Dec. 23th, 2024

MAM* Series Filter Element Appearance Change Notification

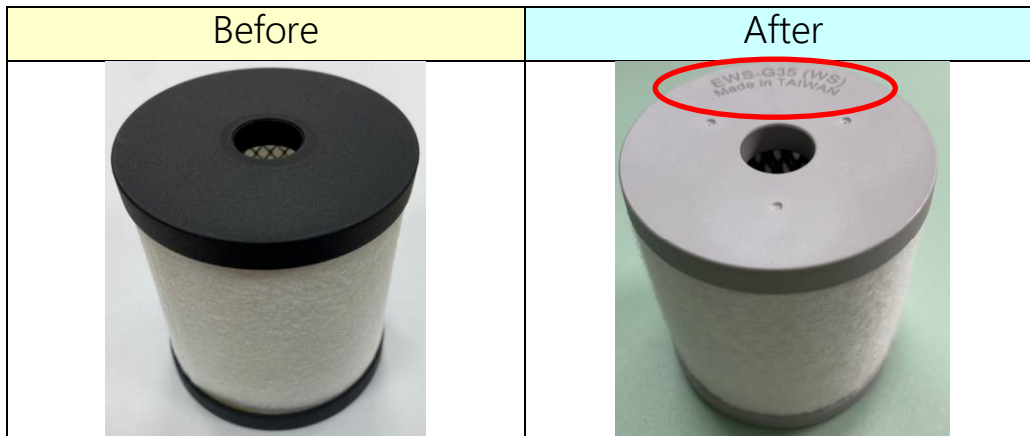
3.1 The appearance color is changed.

3.2 The specification identification code is changed to the upper cover.
